From: DiSalvo, Rick
Sent: Tuesday, July 06, 2010 5:37 PM
To: 'Carl.Spreng@state.co.us'; 'moritz.vera@epa.gov'
Cc: Surovchak, Scott; Kaiser, Linda; Darr, Bob
Subject: FINAL DRAFT RFLMA CR 2010-04 Proposed monitoring point changes
Attachments: FINAL DRAFT RFLMA CR 2010-04 RFLMA Attachment 2 Modification to Revise Monitoring Points.doc; REDLINE FINAL DRAFT RFLMA CR 2010-04 RFLMA Attachment 2 Modification to Revise Monitoring Points.doc

ROCKY FLATS SITE REGULATORY CONTACT RECORD

Purpose: Rocky Flats Legacy Management Agreement Attachment 2: Modification to Revise Monitoring Points

Figure 1. Monitoring and Dam Breach Locations—Woman Creek Drainage Area

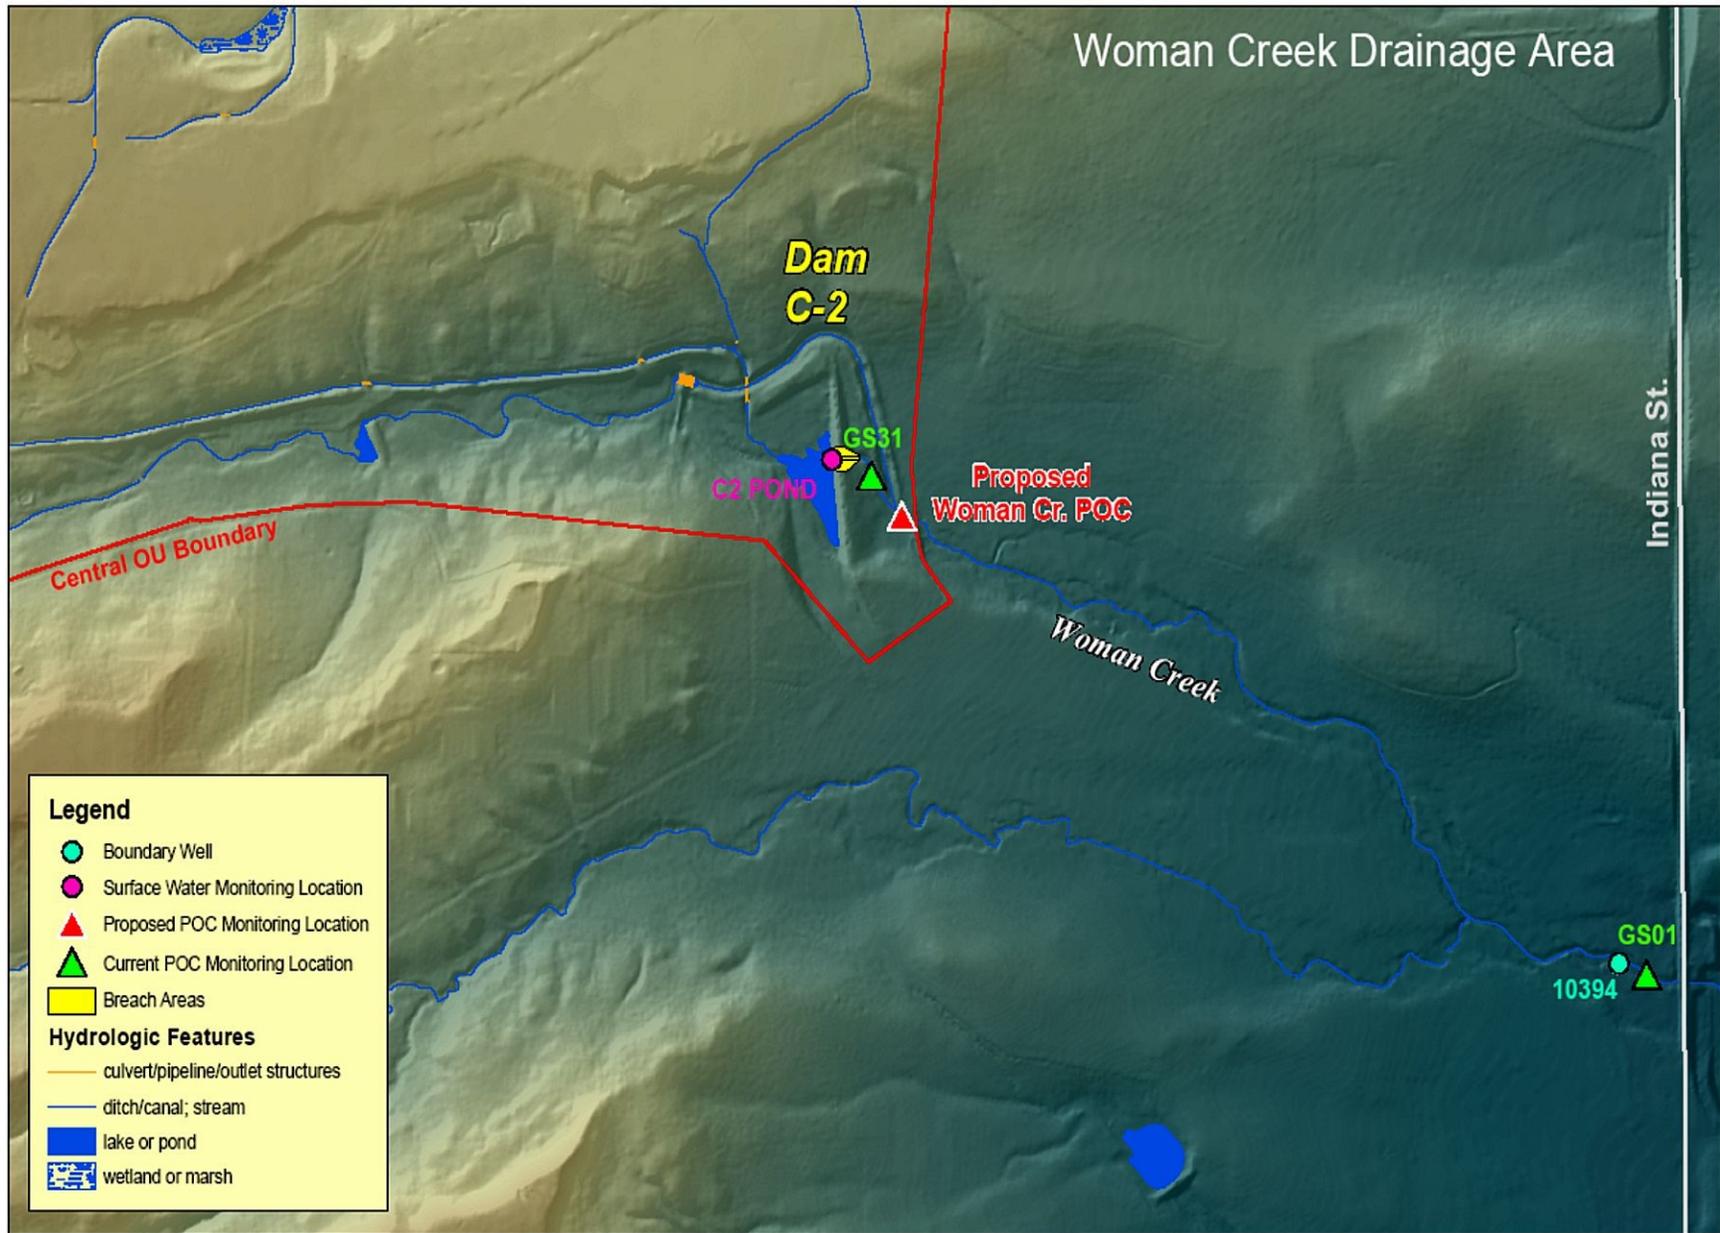
Figures 1 and 2 in this Contact Record also show the current required monitoring locations, the monitoring locations that DOE proposes to eliminate, and DOE's proposed new monitoring locations. The relevant monitoring locations are listed in Table 1 as well. Figures 1 and 2 also show the locations of the remaining ponds and dams and the approximate footprints of the construction areas for the proposed dam breach based on the preliminary design used in preparing the EA.

GS31	Surface water POC—At outfall of Pond C-2 upstream of Woman Creek	Yes	Yes	Replace with new POC in Woman Creek near COU boundary. Compliance value remains based on 12-month rolling average, but DOE will use 30-day rolling average to trigger consultation with CDPHE on whether mitigating actions are required.
PLFPONDEFF	Surface water grab sample location to determine water quality downstream of Present Landfill Treatment System if treatment system effluent exceeds RFLMA standards	No	Yes	A new sampling point ID will be assigned. Grab sample location will be in No Name Gulch near the proposed PLF dam notch after notching. This is the approximate downstream location of the current PLFPONDEFF location.
Pond A-4	Operational monitoring surface water grab sample location for pre-discharge sampling	No	Yes	Remove—operational monitoring not needed; pre-discharge sampling no longer relevant once surface water flow-through condition is restored.

Figure 1. Monitoring and Dam Breach Locations—Woman Creek Drainage Area

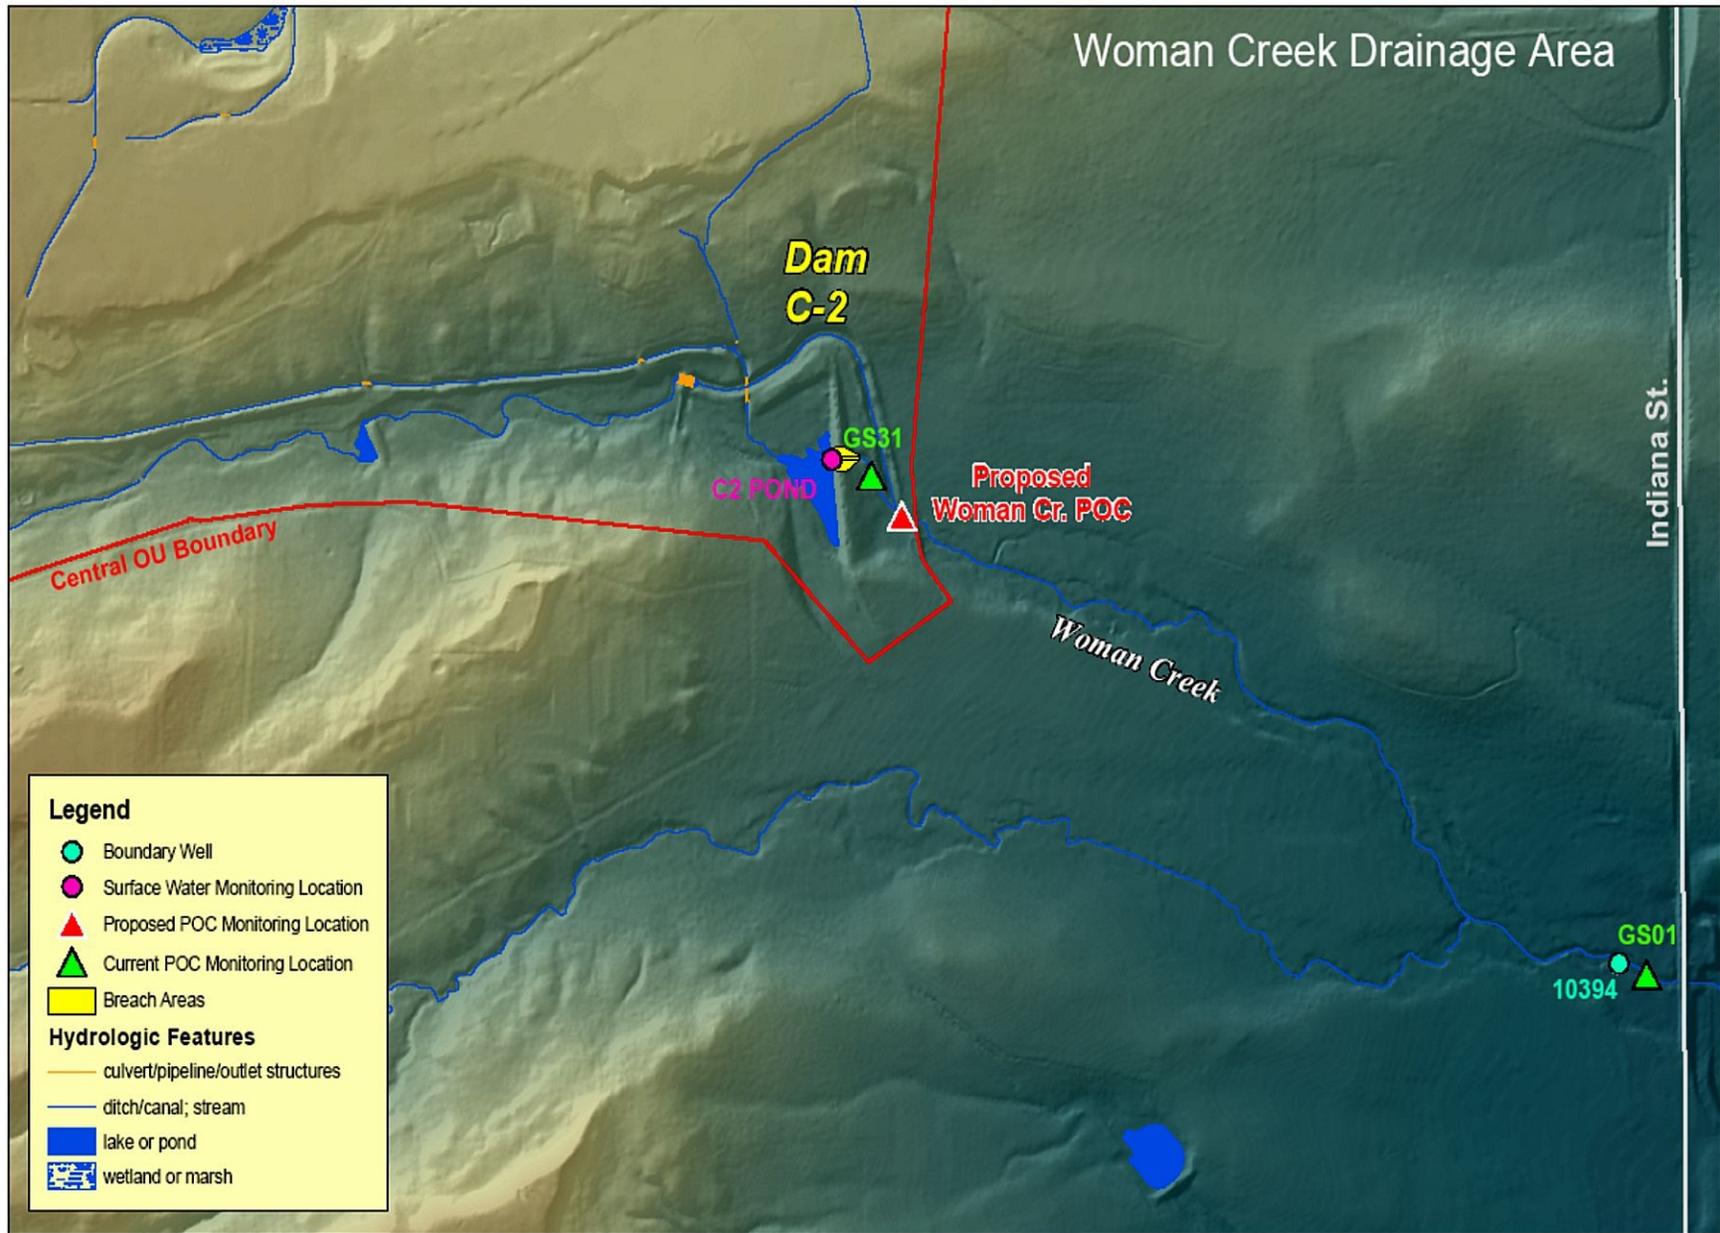
Figures 1 and 2 in this Contact Record also show the current required monitoring locations, the monitoring locations that DOE proposes to eliminate, and DOE’s proposed new monitoring locations. The relevant monitoring locations are listed in Table 1 as well. Figures 1 and 2 also show the locations of the remaining ponds and dams and the approximate footprints of the construction areas for the proposed dam breach based on the preliminary design used in preparing the EA.

GS31	Surface water POC—At outfall of Pond C-2 upstream of Woman Creek	Yes	Yes	Replace with new POC in Woman Creek near COU boundary. Compliance value remains based on 12-month rolling average, but DOE will use 30-day rolling average to trigger consultation with CDPHE on whether mitigating actions are required.
PLFPONDEFF	Surface water grab sample location to determine water quality downstream of Present Landfill Treatment System if treatment system effluent exceeds RFLMA standards	No	Yes	A new sampling point ID will be assigned. Grab sample location will be in No Name Gulch near the proposed PLF dam notch after notching. This is the approximate downstream location of the current PLFPONDEFF location.
Pond A-4	Operational monitoring surface water grab sample location for pre-discharge sampling	No	Yes	Remove—operational monitoring not needed; pre-discharge sampling no longer relevant once surface water flow-through condition is restored.
